RECEIPT DATE: 7/1/15 **ONSITE SEWAGE DISPOSAL SYSTEM** P 556508
 APPROVAL DATE: 9/2/15 SEC **PERMIT: CONSTRUCTION** A _____

PROPERTY ADDRESS: 13112 Greenberry Lane
 SUBDIVISION: Greenberry LOT: 2 TAX ID: _____
 CONTRACTOR: South Carroll Backhoe EMAIL: scbackhoe@comcast.net
 CONTRACTOR ADDRESS: 4410 Salem Bottom Road, Westminster, MD 21157 PHONE: 410-596-3618

RE: Greenberry Tenant House
13110 Greenberry Lane
Building Permit B14004173

GREENBERRY TENANT HOUSE
13112 GREENBERRY LANE, CLARKSVILLE, MD
TAX MAP 28, PARCEL 48
FIFTH ELECTION DISTRICT
HOWARD COUNTY, MARYLAND
SITE PLAN FOR BAT INSTALLATION

FOUNDATION	DATE: 06/12/15	FINAL LOCATION	DATE: N/A
DRAWN BY: MES	CHECKED BY: TMH	SCALE: 1"=50'	
PROJECT NO.: 12-022	LOCATION DRAWING

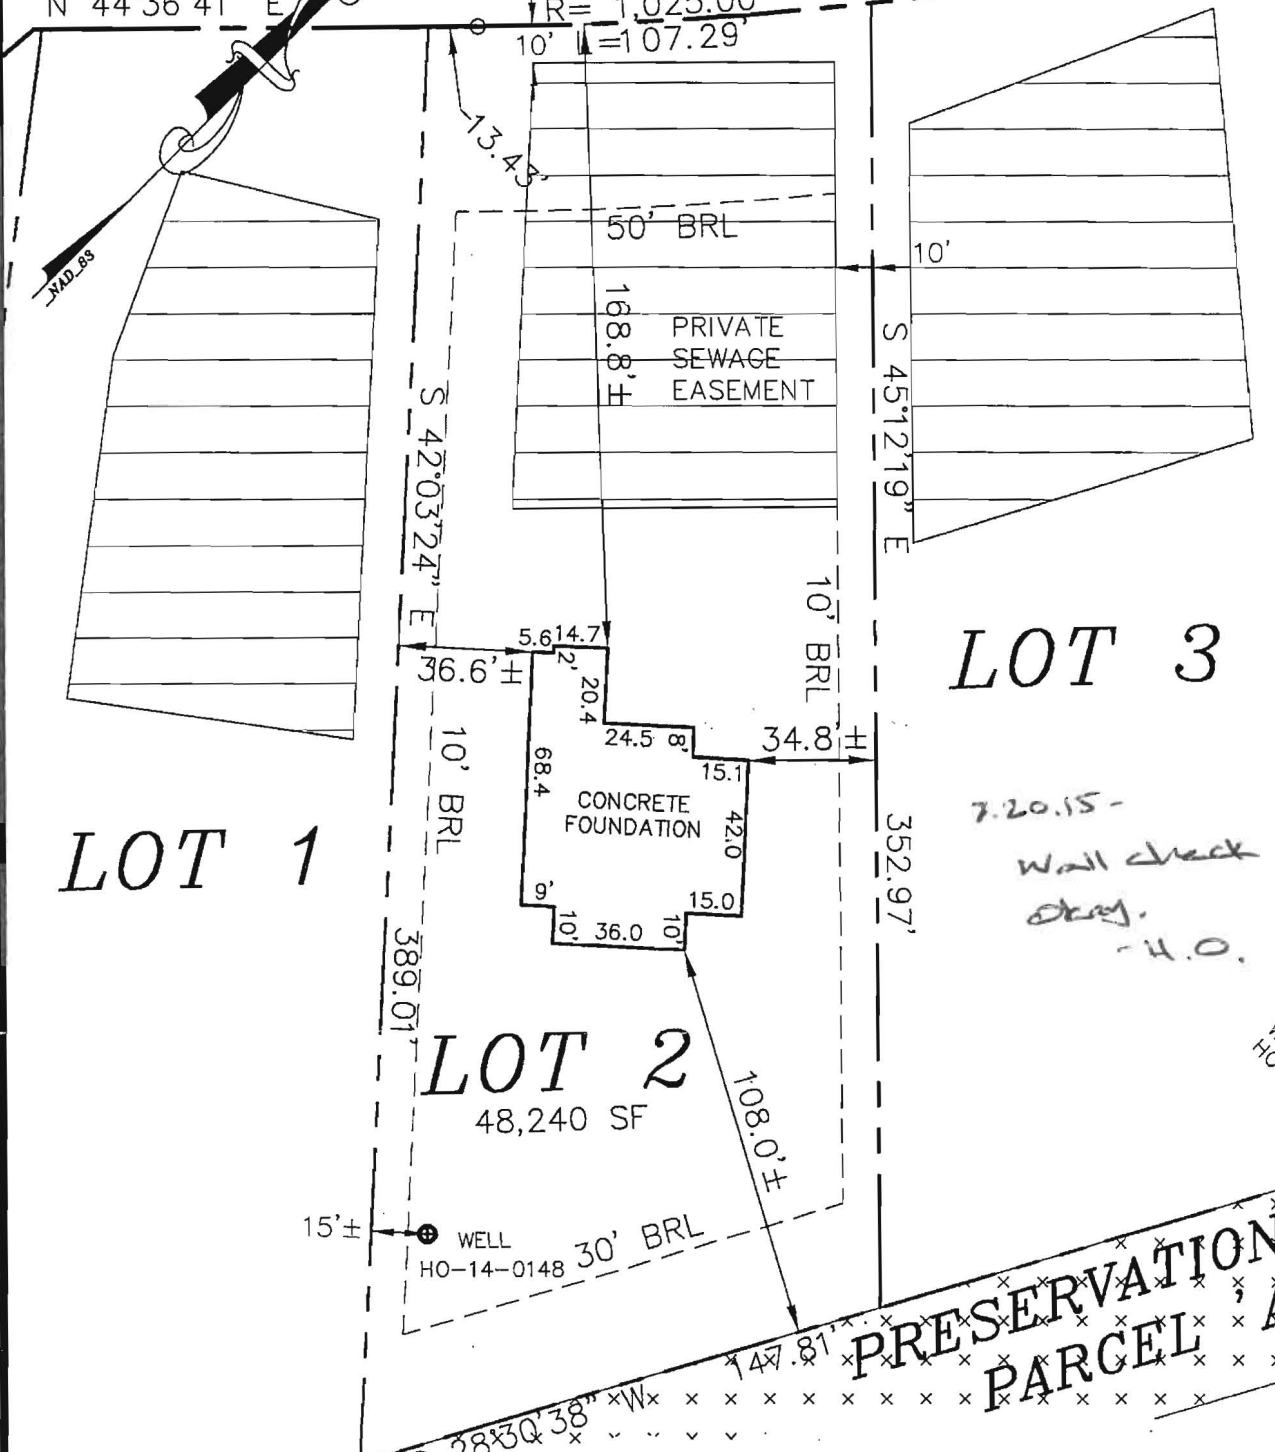
7.20.15 -
wall check
okay.
- H.O.

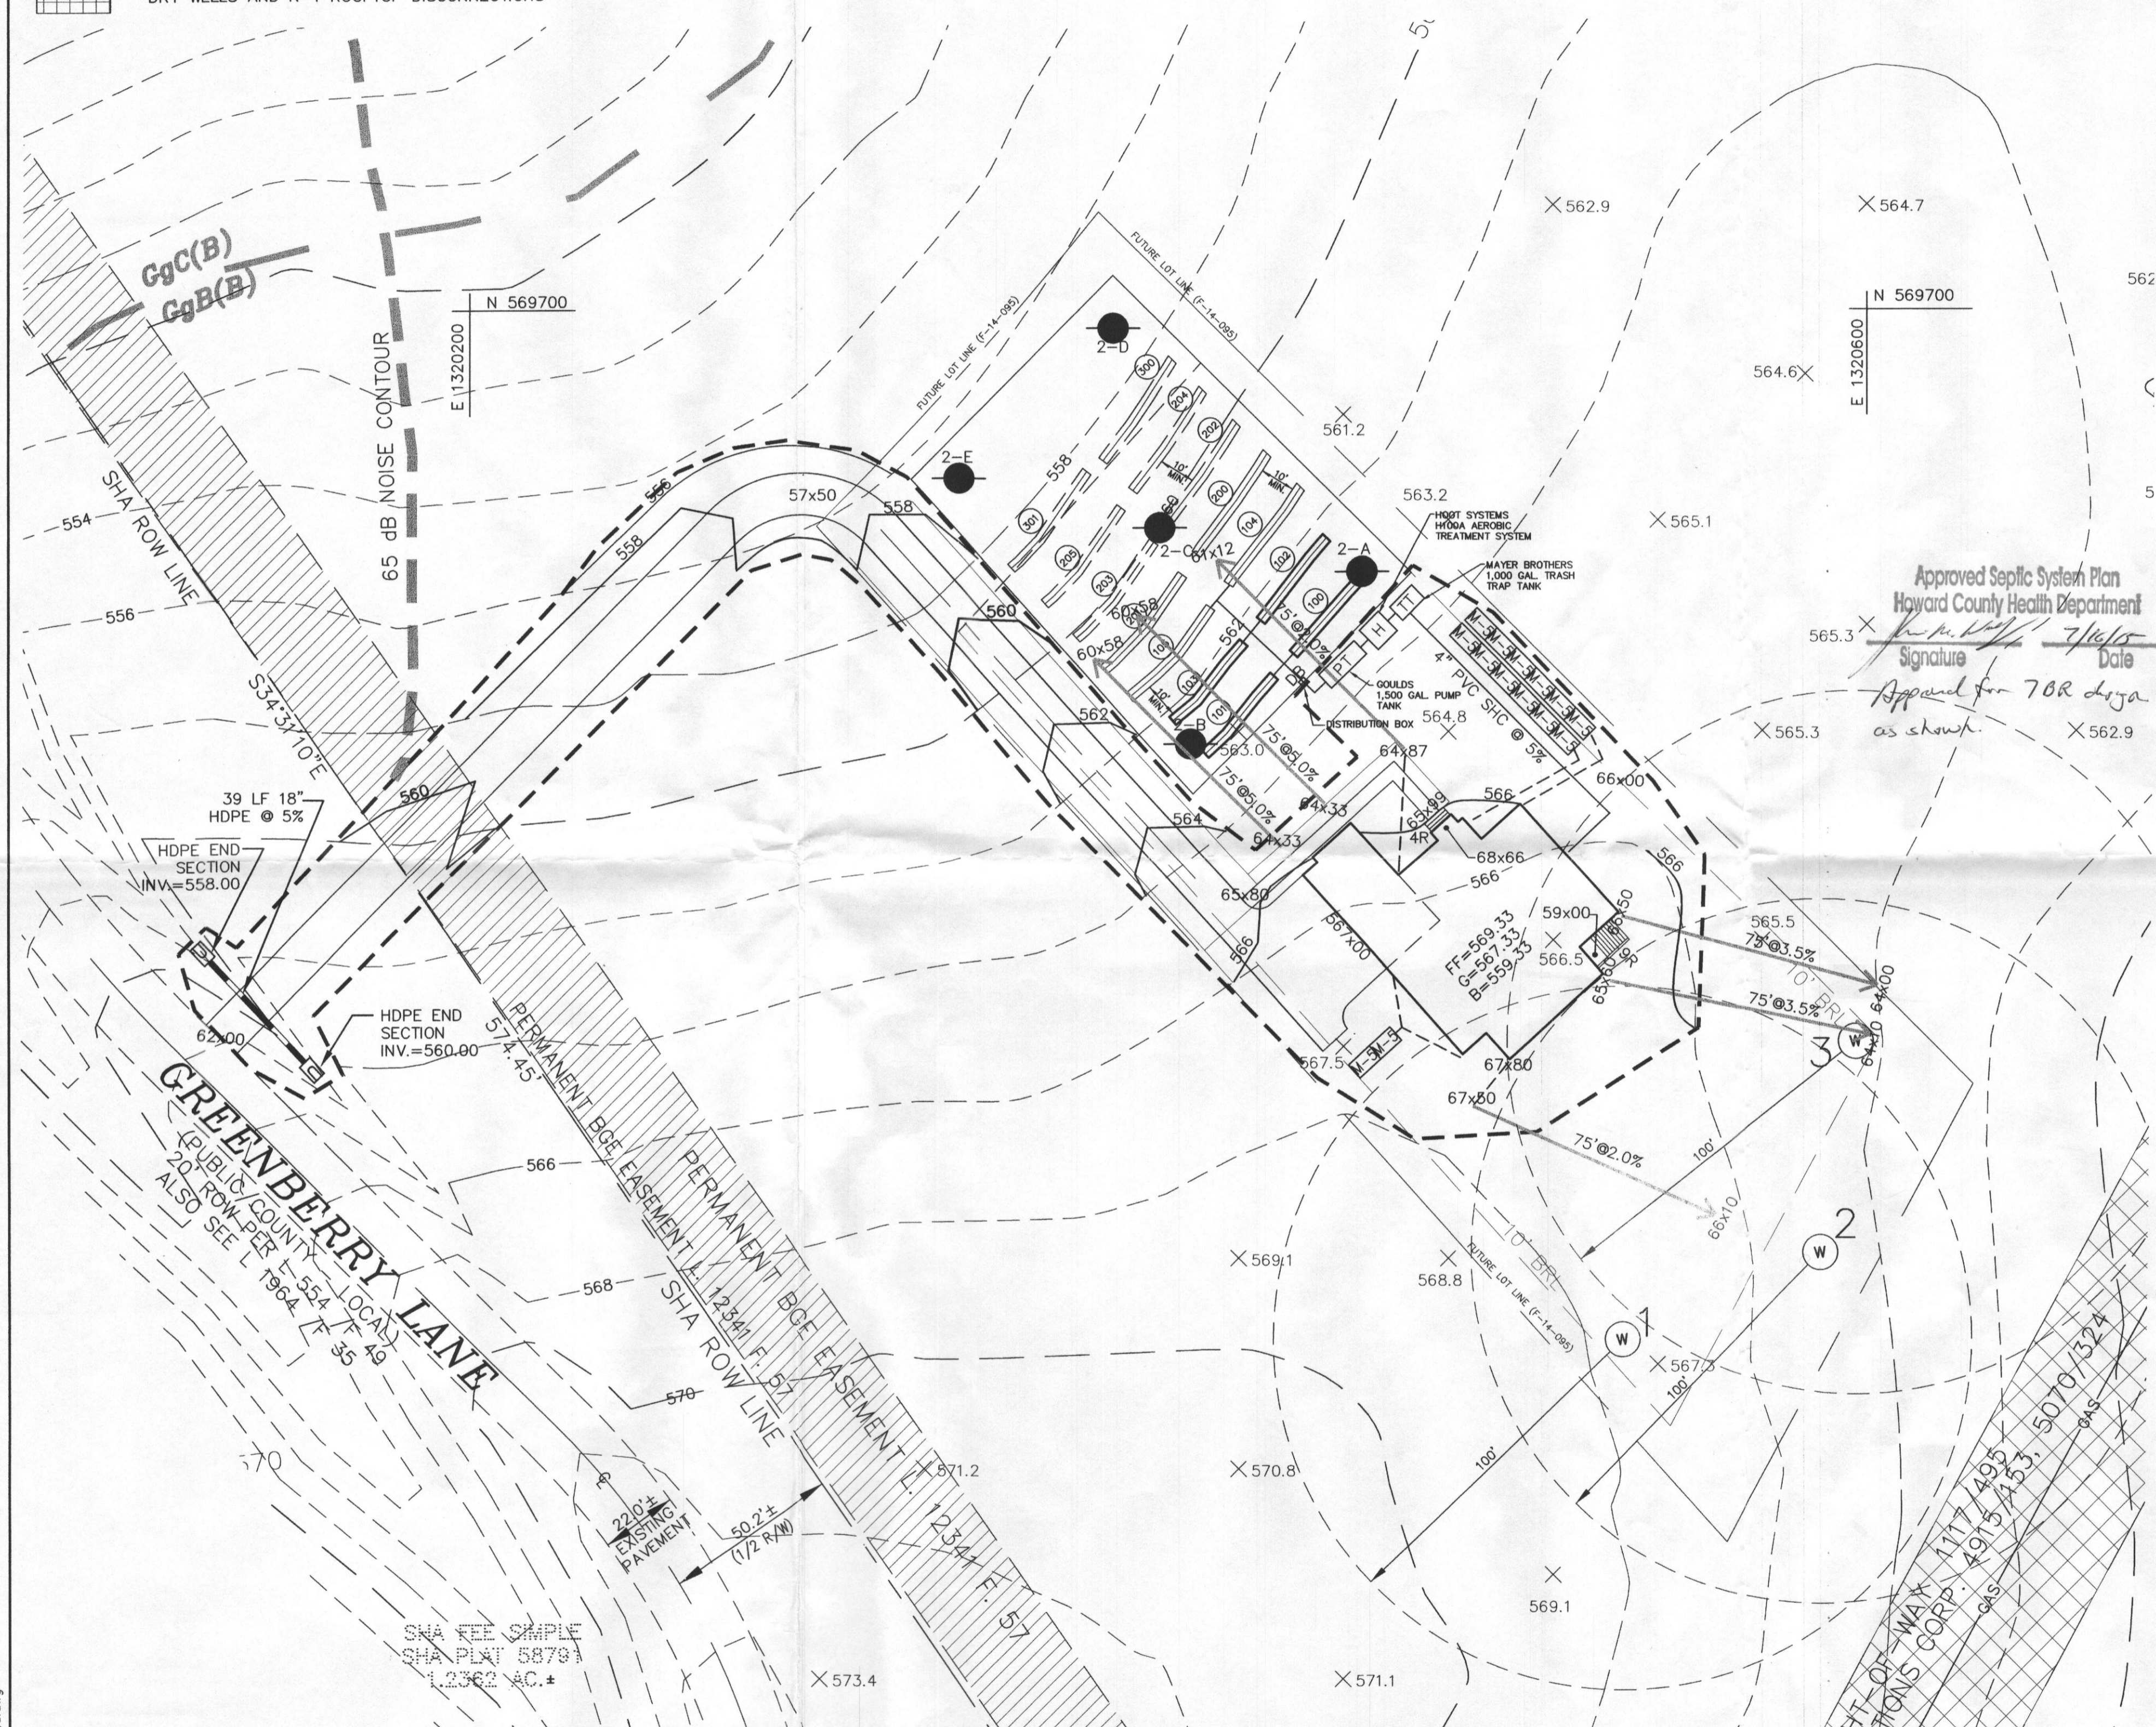
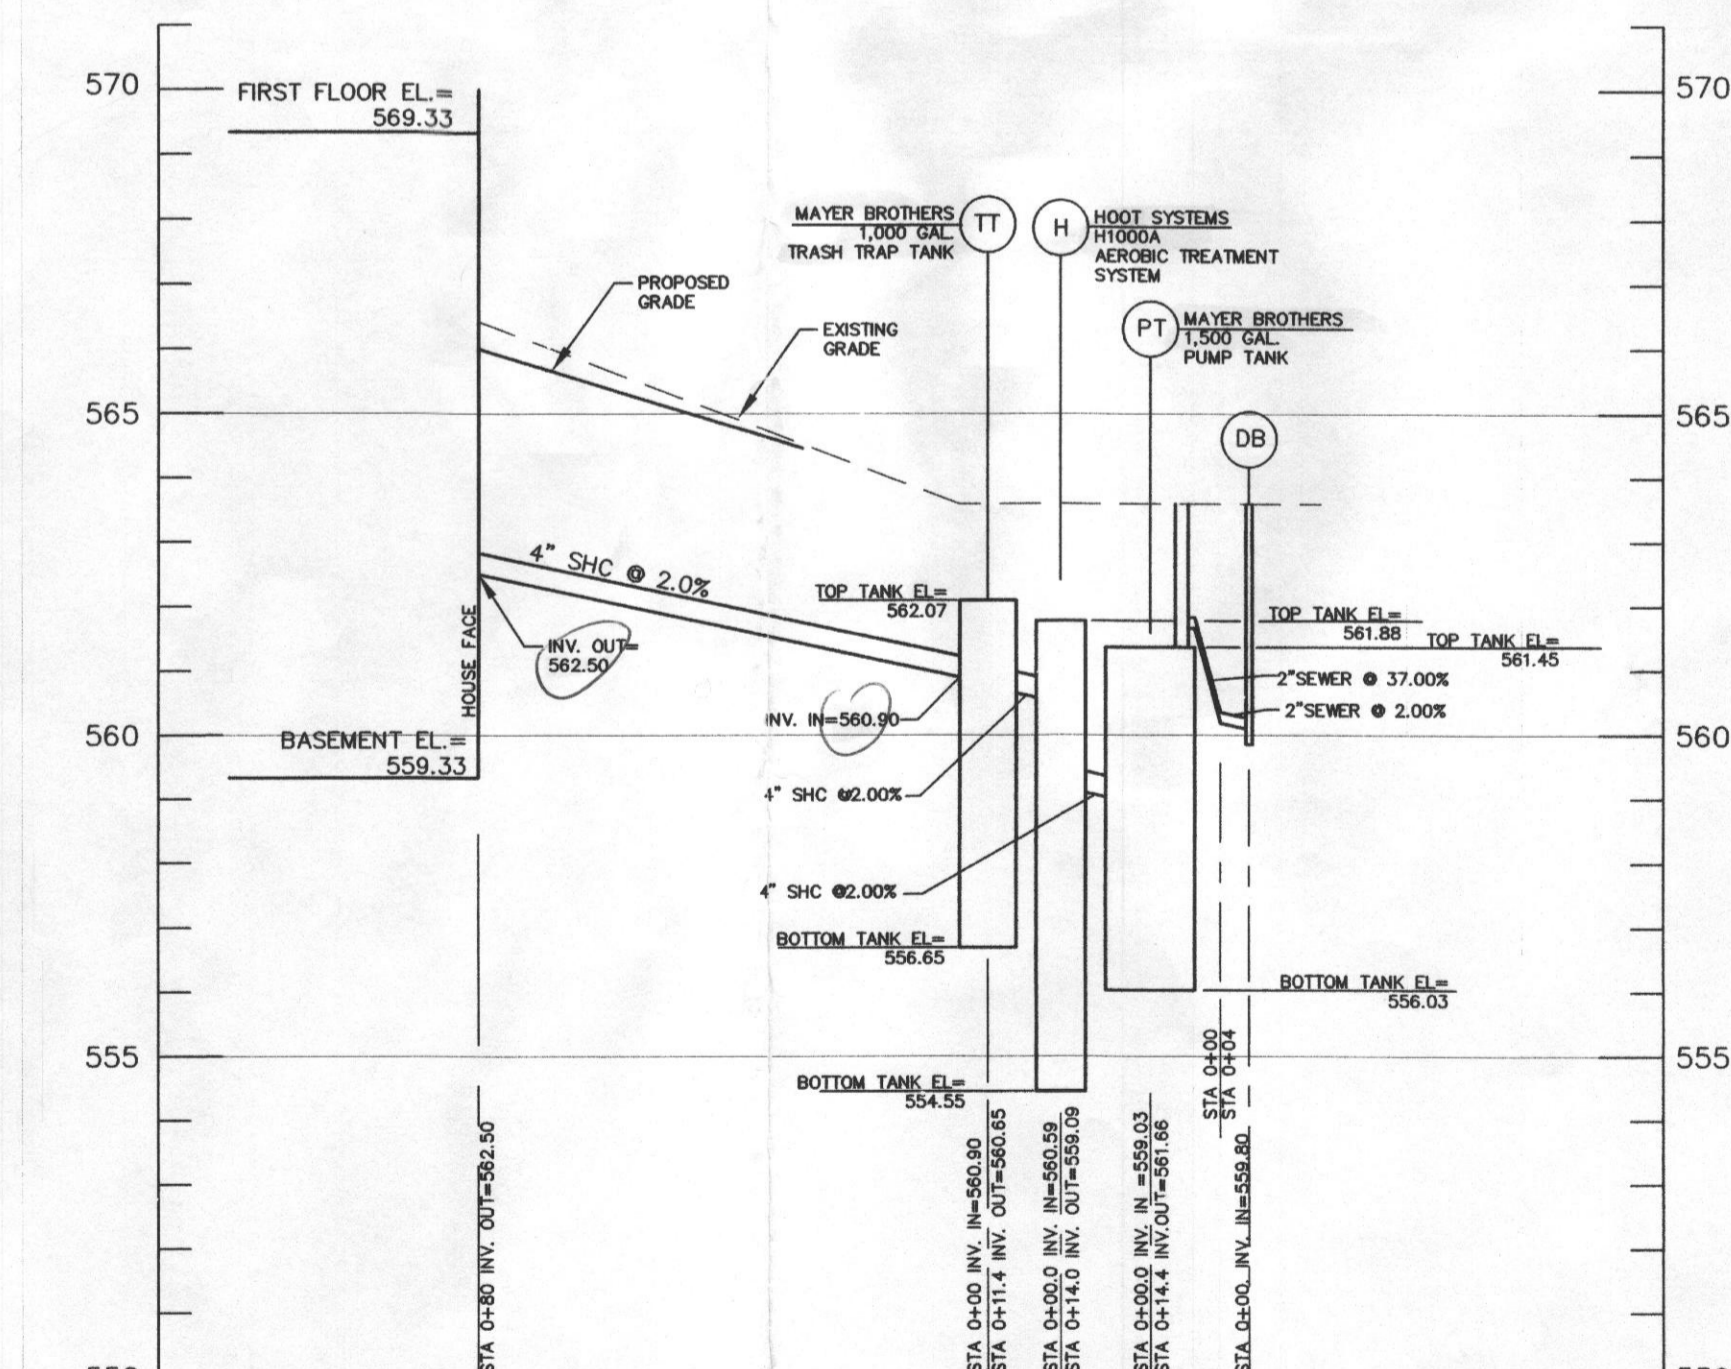
According to the trench data chart on the plan, the figures show an invert at 3.5 ft. and a bottom maximum depth of 5.5 ft. This is acceptable except you aren't using the maximum side wall credit of 0.38 (with a bottom trench depth of 8 ft.). Therefore, the trench length requirement will be greater than a design with an effective depth of 4.5 ft.

Ex. If the invert is at 3.5 ft. and the bottom of the trench is at 8 ft. then the effective depth is 4.5 ft. Utilizing the formula $W+2/W+1+2(D)$, the side reduction wall credit = $3 + 2 / 3+1+2(4.5) = 5/13 = 0.38$ (not 0.62) reducing the required trench length from 180.84 to 110.83

If you don't wish to change the effective depth/calculations on the plan, then all we need added at this point is a "certification note" stating that the manufacturer certifies this unit is adequate for this particular design at 7 bedrooms. You could be done at our office or you may submit a revised BAT plan with the note on it.

Approved Septic System Plan
Howard County Health Department
Signature: [Signature]
Date: 7/16/15
Approved for 7BR design as shown
